August 20, 2021

Re: Comments on ENERGY STAR Residential Window Draft 1 Version 7 Specification

Figure A. U-Value for Zero Energy Ready Home Builders

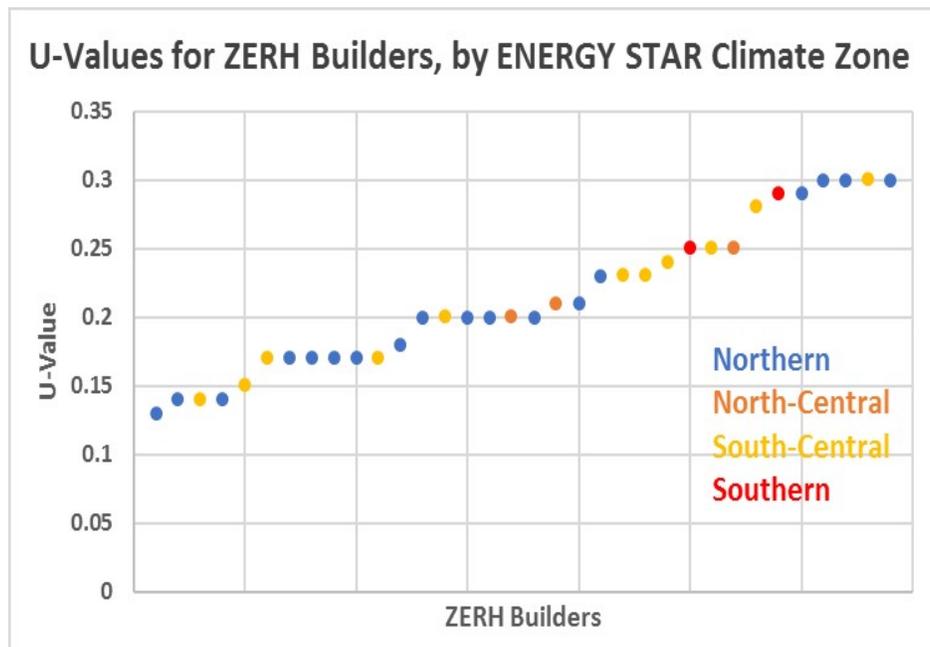
purchases for the homes they build. While the DOE ZERH builders interviewed are required to install windows that meet the current ENERGY STAR window criteria as a mandatory requirement for certifying their homes as ZERH, the survey revealed that many of these builders go beyond the current ENERGY STAR levels, which implies they have already determined that the benefits of doing so, outweigh any costs associated with these higher performing windows. Figure A (below) shows the U-factors of the windows that builders use, where builders who build in more than one climate zone are represented by more than one data point and each data point can represent multiple homes built in a given year. Over 60% of the builders are currently installing a window rated at R-5 or better (U-value  $\leq 0.20$ ), and over two-thirds of the builders in the ENERGY STAR northern climate are meeting or beating an R-5 window.

In addition to the thermal insulating performance, the builders surveyed noted that homebuyers value the noise reduction, increased comfort, and reduction in interior condensation that come with higher performing windows, which is why most of the ZERH builders are able to justify exceeding the current ENERGY STAR specification even though it is not a requirement of the ZERH program. Several builders also noted that building with triple-pane windows offers them additional flexibility with wall and HVAC design, allowing for smaller sized mini-split HP units, when this is desired.
